**ADDENDUM NO. 7****DATE:** April 28, 2022**CONTRACT NO.:** HU-0029-B01**PROJECT:** UNION CITY - NEW GRADE 7 THROUGH 9 SCHOOL

DESCRIPTION: **Union City - New Grade 7 through 9 School**
 Union City, NJ
 Addendum No. 7

DRAWING #
(A1-101)E-15a

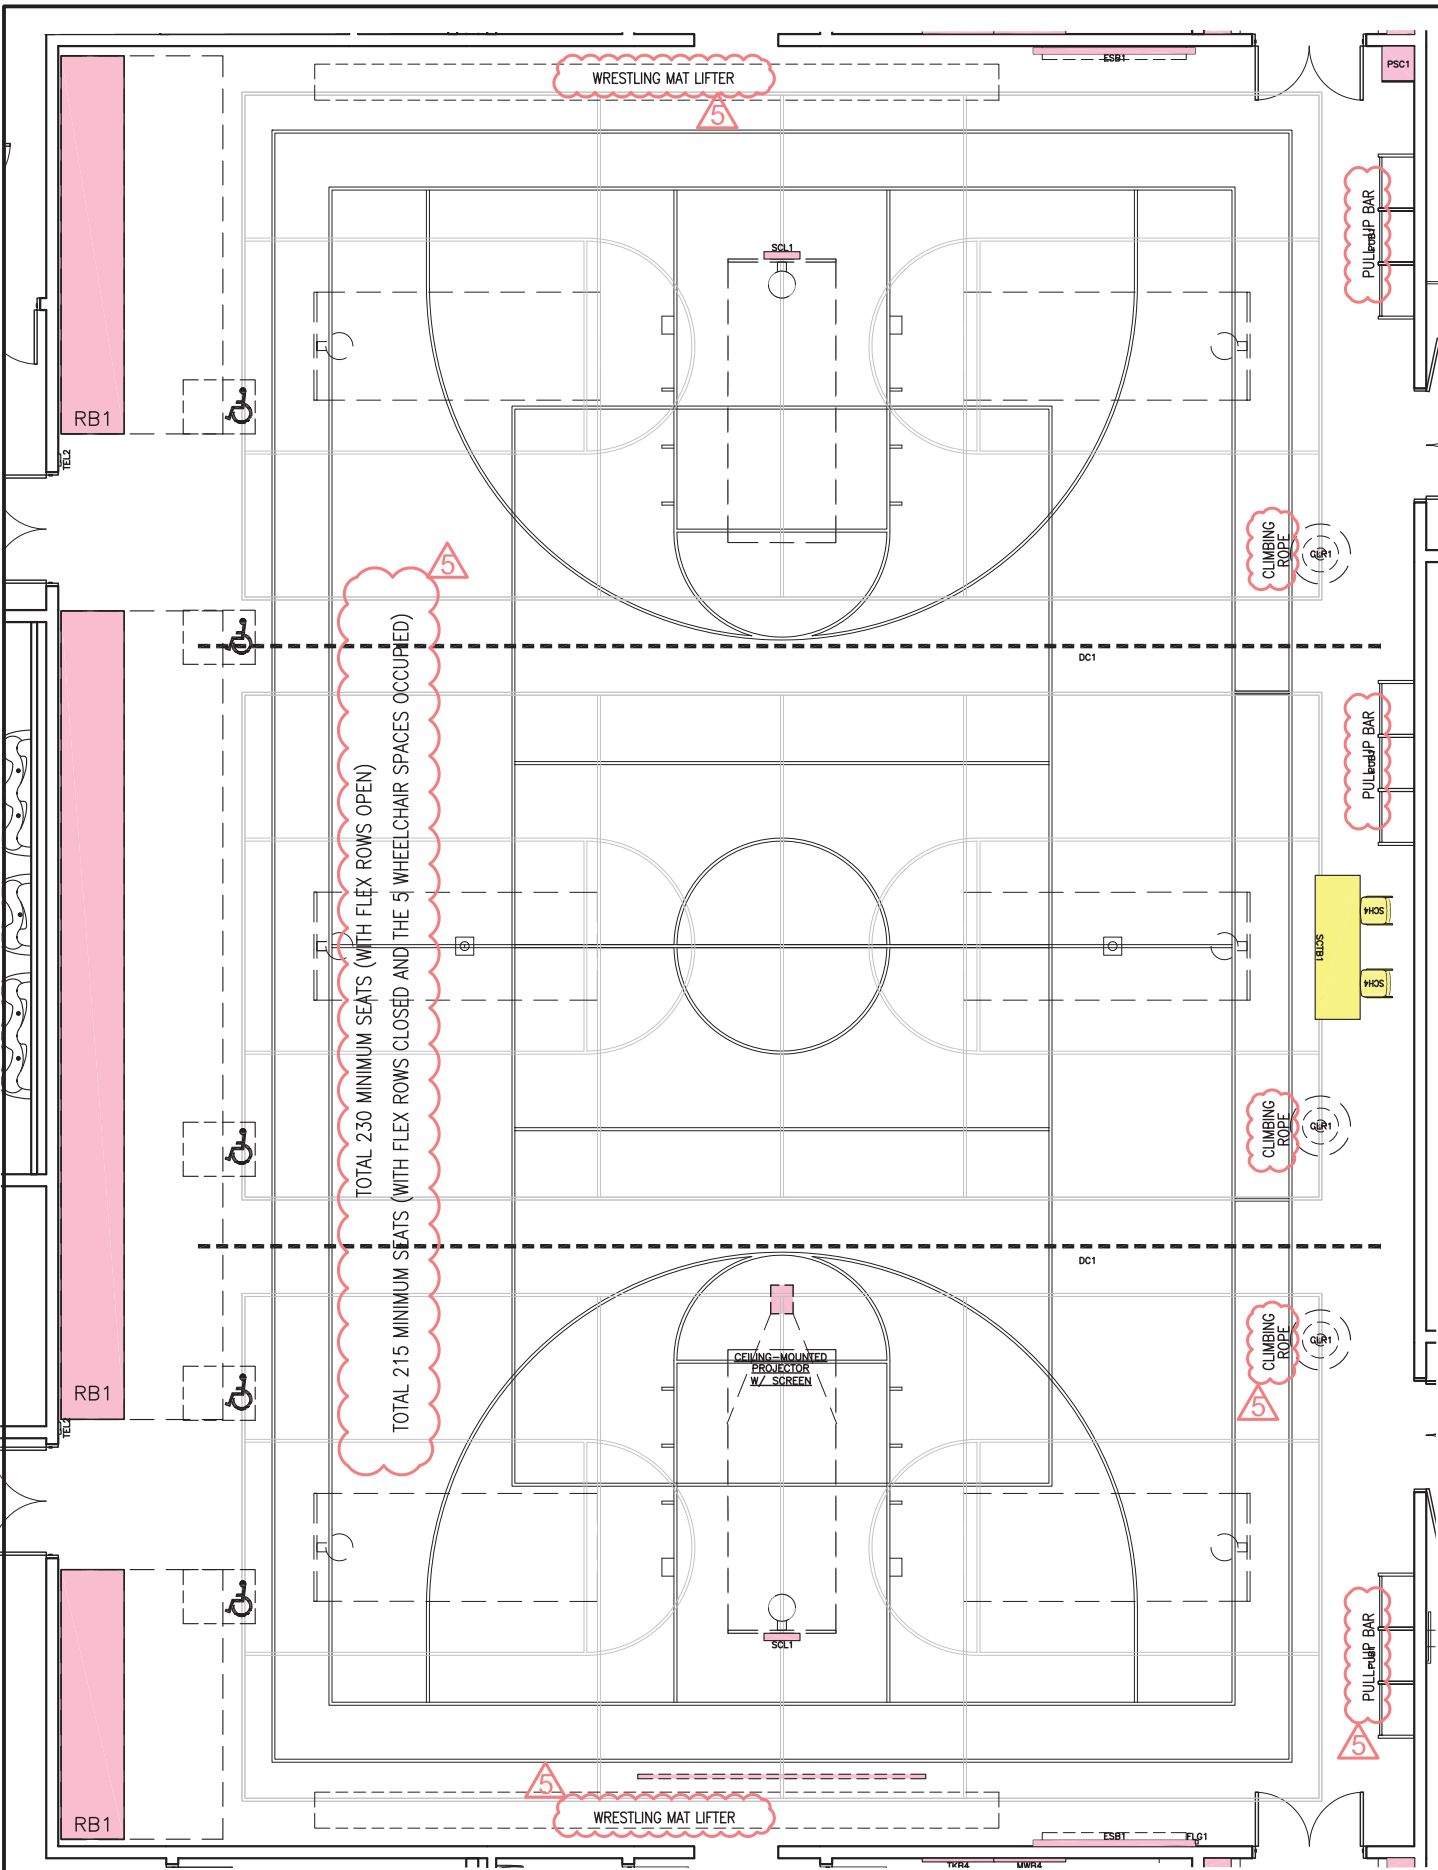
7. **QUESTION:** Pull up bars in gym, there is no elevation, where or what they are. How many are required, what type and where? (BQ 433)

8. **QUESTION:** Climbing ropes, there is no drawing that shows where they are, what types are required, where are they attached, where do they go? Is a hoist system required for them? (BQ 434)

9. **QUESTION:** Scoreboards, where do they go? It says to provide a direct wired one and a wireless one. Which one is required to be wired and which one wireless. (BQ 435)

10. **QUESTION:** Matt lifters. Where are they to be located, should steel be added? What types are required? Documents state a single hoist, is this correct? (this is hardly ever used). (BQ 436)

11. **QUESTION:** Basketball backstops, 8 are required, documents state 2 premium what are premium? 6 standard units what does standard units mean? (BQ 437)

12. **QUESTION:** Shot clocks where are they going? (BQ 438)

RESPONSE: Three (3) PUB1 Pull-up Bars shall be mounted on the job-East interior elevation of room A-110 Gymnasium. See the room layout and fit-out list E-15a Gymnasium. Regarding the basis of design for the pull-up bars see Addendum 4, section E Bidder Questions, Requests for Information and responses, item #59.

RESPONSE: Three (3) CLR1 Climbing Ropes shall be mounted in room A-110 Gymnasium. See the room layout and fit-out list E-15a Gymnasium. Regarding the basis of design for the climbing rope see Addendum 4, refer to item B.2.o.

RESPONSE: Two (2) ESB1 Electronic Scoreboards CLR1 shall be suspended at the job-North and South ends of room A-110 Gymnasium. See the room layout and fit-out list E-15a Gymnasium and performance specification E1070.00 Entertainment and Recreational Equipment as modified herein. The D-B shall provide one direct wired and one wireless scoreboard controller. See performance specification E1070.00 Entertainment and Recreational Equipment, paragraph II.B.7.e. Either controller shall operate both scoreboards simultaneously.

RESPONSE: Two (2) WREL Wrestling Mat Lifters shall be suspended at the

job-North and South ends of room A-110 Gymnasium. See the revised room layout and fit-out list E-15a Gymnasium, attached. The basis of design for the mat lifters is NGE model 500. See performance specification E1070.00 Entertainment and Recreational Equipment, paragraph II.B.5.a.

RESPONSE: All six (6) basketball backboards are identical. See the revised room layout and fit-out list E-15a and E-15b Gymnasium, attached.

RESPONSE: Provide two (2) SCL1 Basketball Shot Clocks mounted above the competition backboards. See room layout and fit-out list E-15a and E-15b Gymnasium and performance specification section E1070.00 Entertainment and Recreational Equipment as modified herein.

NJSDA PROJECT # 5240-N10-16-0AEN | DOE PROJECT # 5240-N10-16-1000
DATE JULY 06, 2021
DRAWING # (A1-101)E-15b

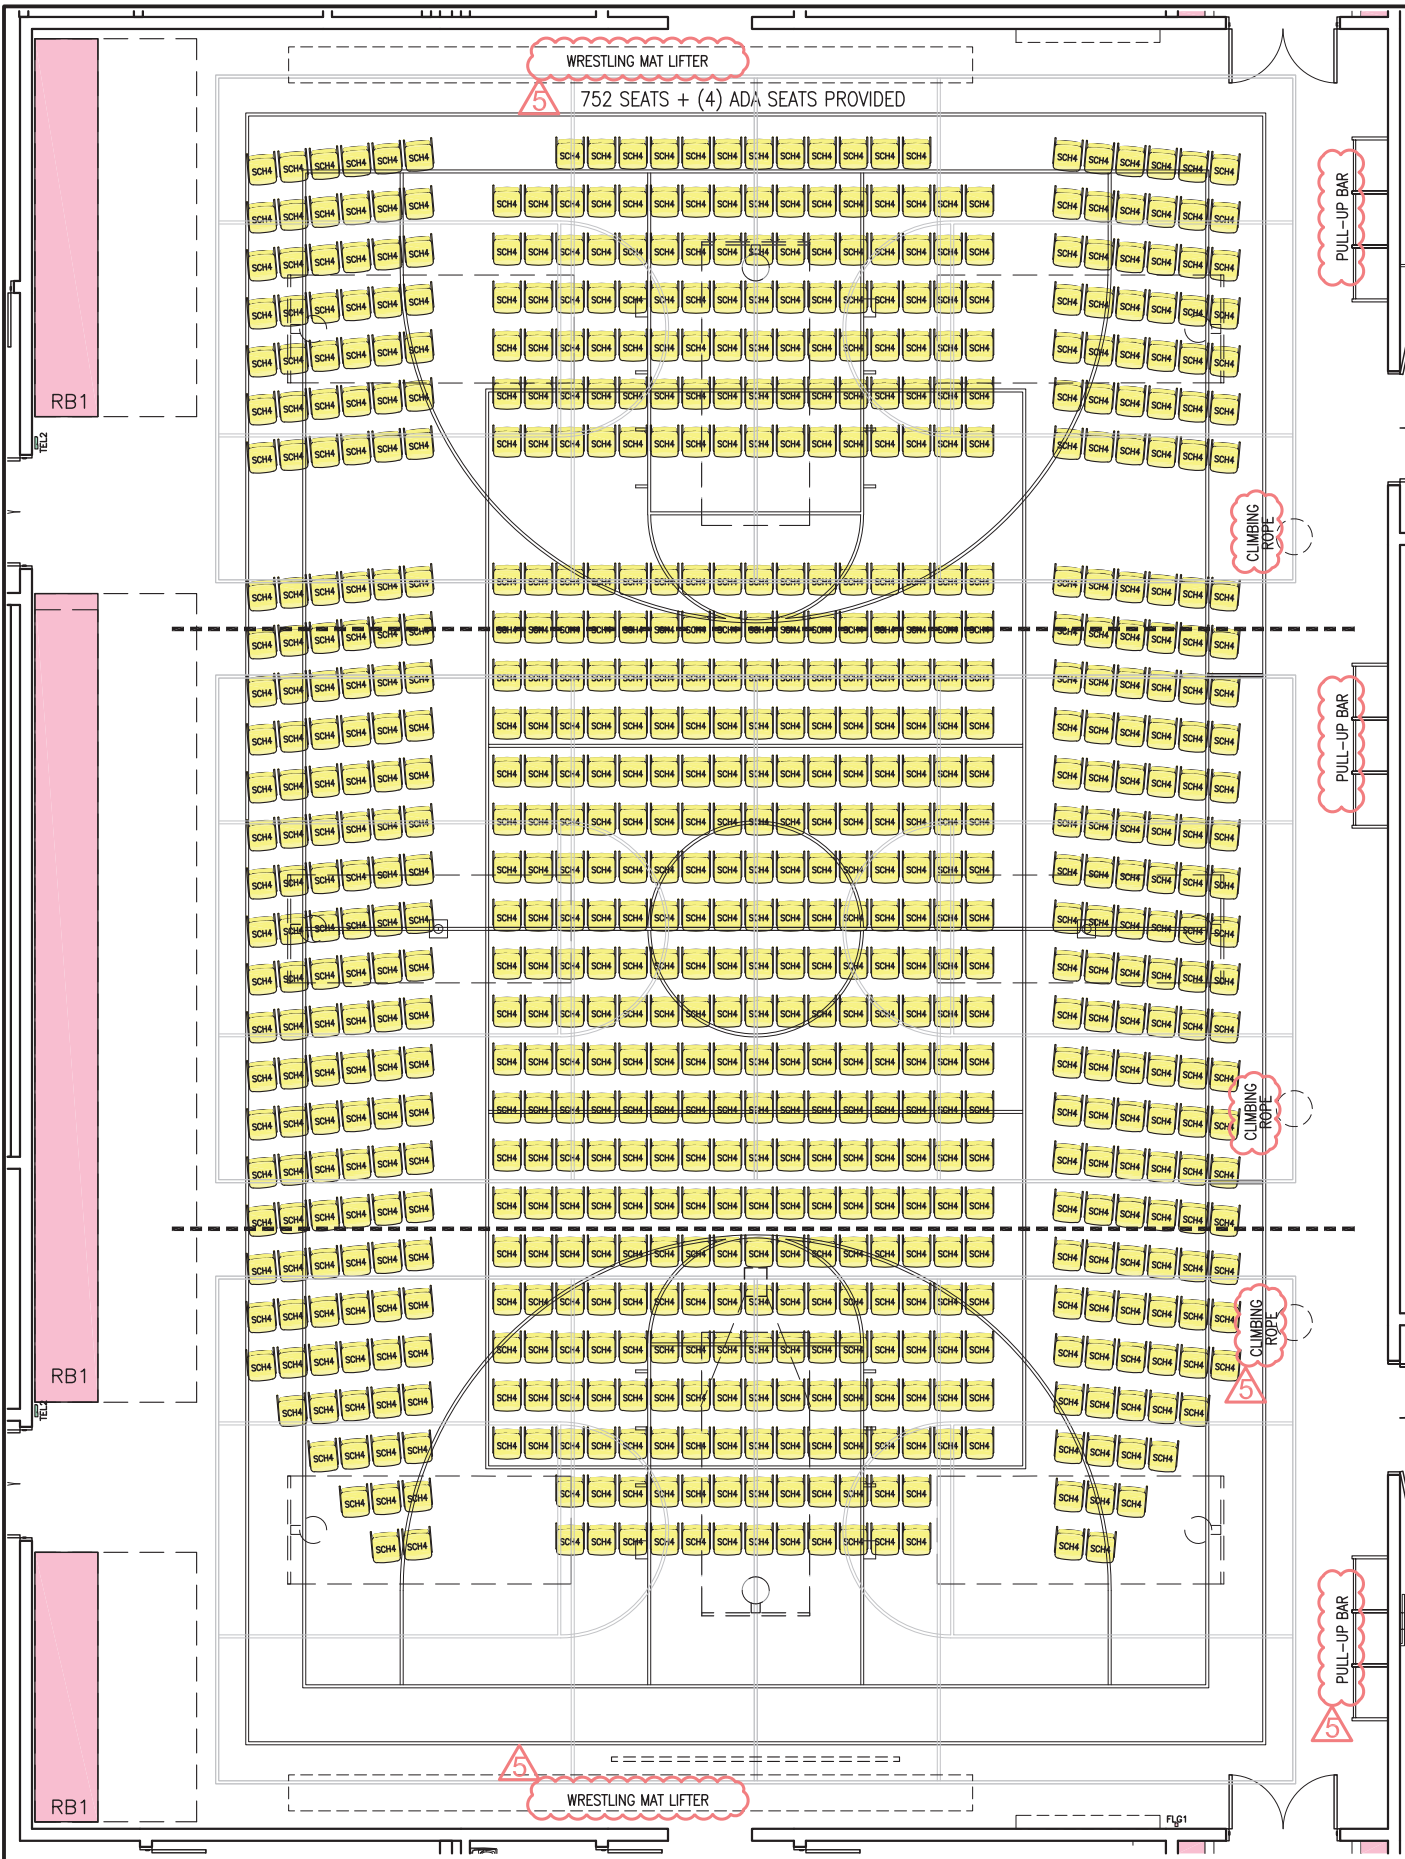
14. **QUESTION:** Bleacher design on drawing A-101 does not meet code, which code have you followed in designing those? (BQ 440)

RESPONSE: See the revised room layout and fit-out lists E-15a and E-15b Gymnasium and drawing A-101 First and Second Floor Plans, attached and refer to item B.2.h in this Addendum.
